Appeal of Technical Information from FEMA presented 26 September 2000

26 October 2000

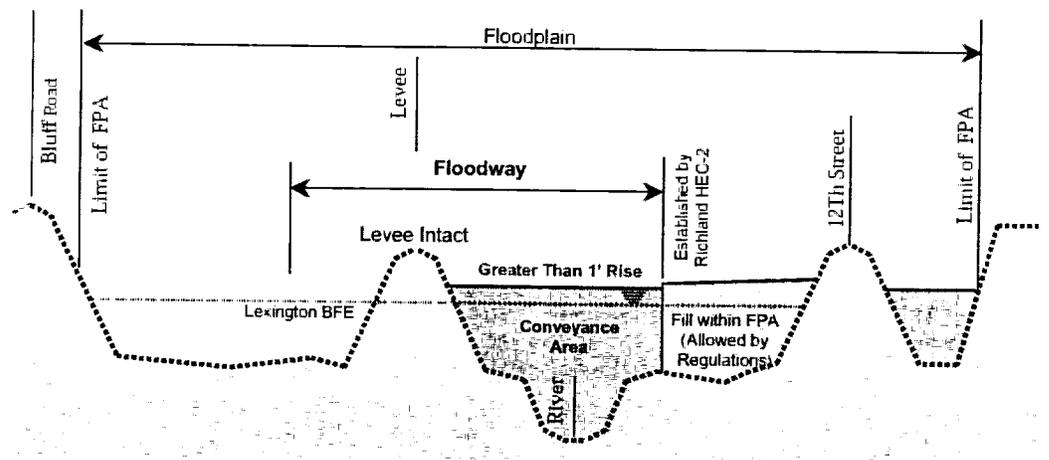
- By using the Richland County HEC-2 model (levee out) for floodway determination increases the risk of flooding.
- FEMA's currently proposed floodway assumes a condition that may not occur, as described below
 - Flow conveyance occurs for full width of floodway.
 - Levee is removed as a barrier or impediment to flow by the floodway.
 - Richland and Lexington Counties are developed (new construction) to floodway limit.

- The highest potential for flooding exist when:
 - The levee remains intact as barrier to flow.
 - Lexington is fully developed (new construction) to the floodway limit.
 - Flow does not occur for the full width of the floodway.

- In order to maintain 1' maximum surcharge Lexington floodway should be set with levee intact. Use the Lexington HEC-2 model (levee in) for Lexington County Floodway.

Figure 1 – FEMA Hydraulic Grade Elevation

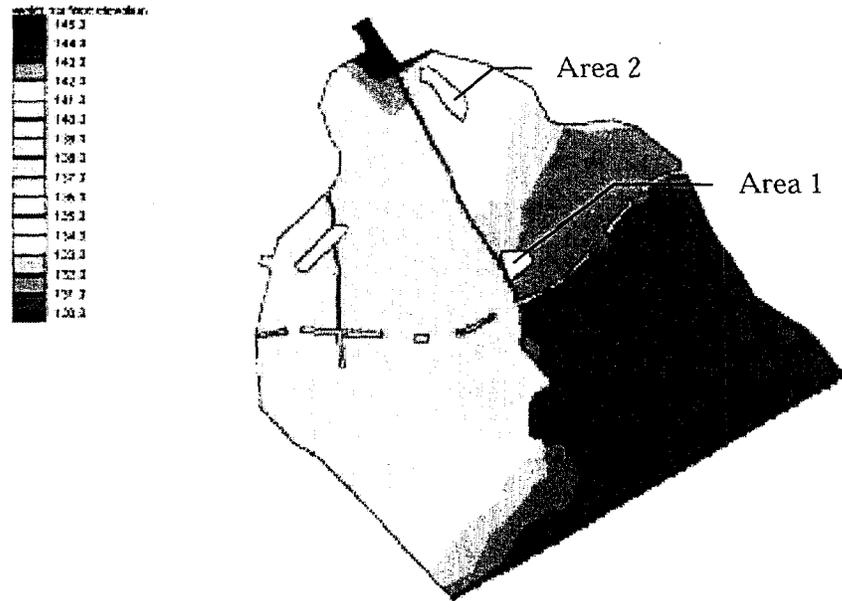
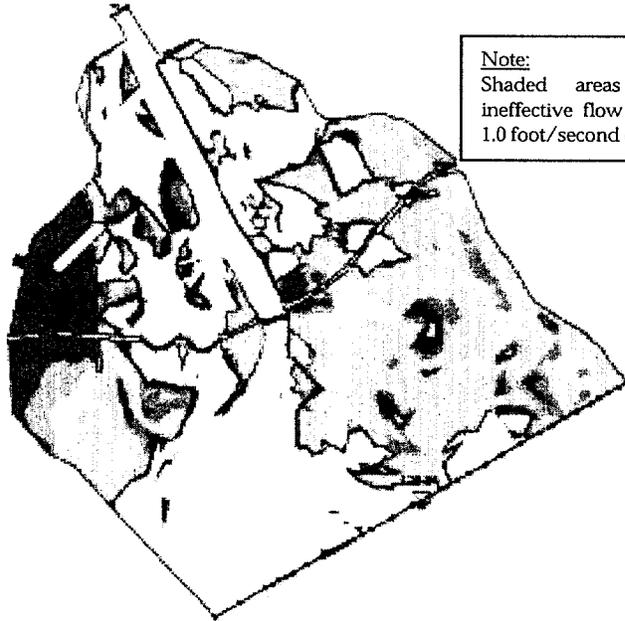
- The area surrounding the City of Columbia WWT facility (noted as Area 1 on Figure 1) is indicated as a wet/dry boundary, but this may not be appropriate since grade at the wastewater treatment plan varies from 127 – 140 feet in elevation. Figure 1 taken from the FEMA provided double piping breach scenario (refin.geo and refin129.sol) files indicate that the water level is approximately 131 to 133 feet; therefore, portions of the area should be excluded from the wet/dry boundary.

- The wet/dry boundary located north of Heathwood Hall (noted as Area 2 on Figure 1) is not appropriate since elevation in that area is approximately 130 feet based on the USGS map (topographic survey is not available) Figure 1 taken from the FEMA provided double piping breach scenario (refin.geo and refin129.sol) files indicate that the water level is approximately 137 to 134 feet, therefore, the area should be excluded from the wet/dry boundary. The removal of this wet/dry boundary will reduce the velocity in the northern area of the levee interior.

Figure 2 - Velocity Less Than 1 Foot per Second at Q = 292,000 cfs

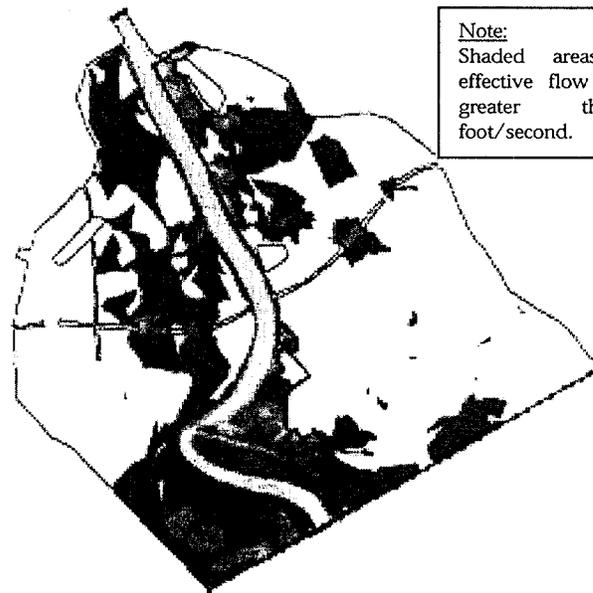
- On page 19 of the “Appeal Resolution for Congaree River in Richland and Lexington Counties, South Carolina” document, effective flow behind the levee is defined as water velocity greater than 1.0 foot per second. Figures 2 and 3 taken from the FEMA provided double piping breach scenario (refin.geo and refin129.sol with $Q=292,000$) files indicate that the water velocity is less than 1 foot per second south of I-77; therefore, portions of the area should be defined as ineffective flow. In fact the areas north of I-77 cannot be considered effective flow when it does not pass through the downstream portion of the property as effective flow.

Figure 4 - North Breach Rating Curve

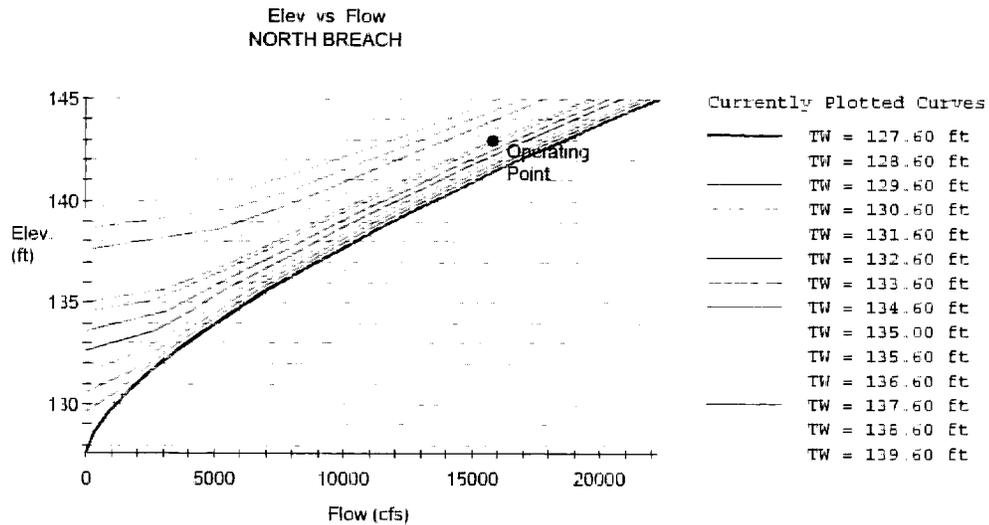
- Flow rates behind the levee from the two models are not consistent.
 - The Richland HEC-2 model indicates a flow rate behind the levee varying between 22894 cfs to 179583 cfs See the Table 3 above.
 - Lockwood Greene prepared independent calculations based on the geometry and head conditions of the FEMA RMA-2 northern breach (120' wide) that indicates a flow rate of 15900 cfs. The southern breach (120' wide) yielded a flow of 10400 cfs. The

combined total flow through the two breaches is 26300 cfs. See Figures 3 and 4 for rating tables of the breaches.
